PCI-SIG ENGINEERING CHANGE REQUEST

TITLE:	Restructure OCuLink Power Specification Appendices ECR [R1.1]
DATE:	April 6, 2018
AFFECTED DOCUMENT:	OCuLink 1.0
SPONSOR:	Jay Neer, Alex Haser – Molex

Figure C 1. Instantaneous and Sustained Peak Current for 3.3 Vact TX and 3.3 Vact RX

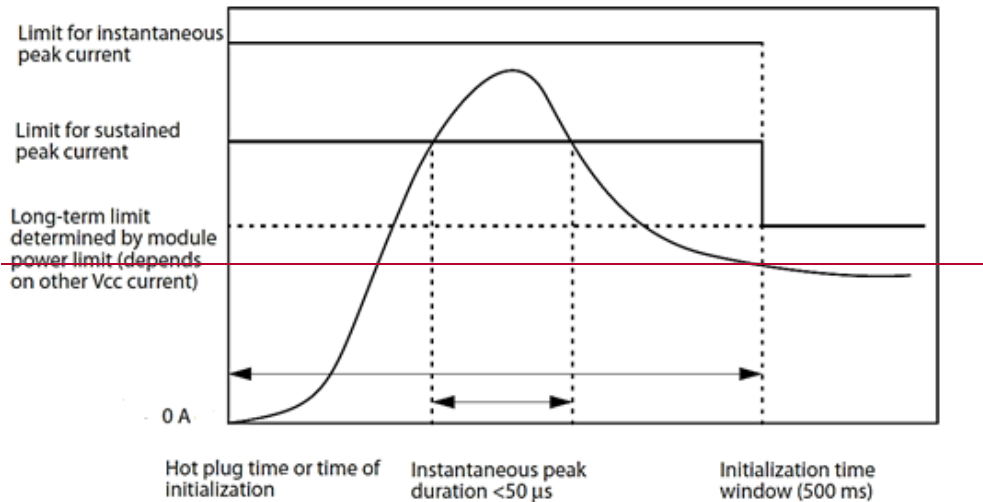
- a. Title revised to: Requirements for Optional Peripheral Power in External Cables
- b. Appendix restructured into 4 sections: Power Source, Hot Plug, Power Sequencing, and Power Decoupling ~~plus the Power Requirements Table and the Peak Current Figure~~
- c. All content now addresses only the requirements for optional peripheral power in external cables.

~~To avoid exceeding system power supply limits and cooling capacity, all cables at power up, by default, must operate with ≤ 1.5 W. The maximum power level is allowed to exceed the classified power level for 500 ms, following hot insertion or power up. However, the current is limited to values given by Table C-1 and illustrated in Figure C-1.~~
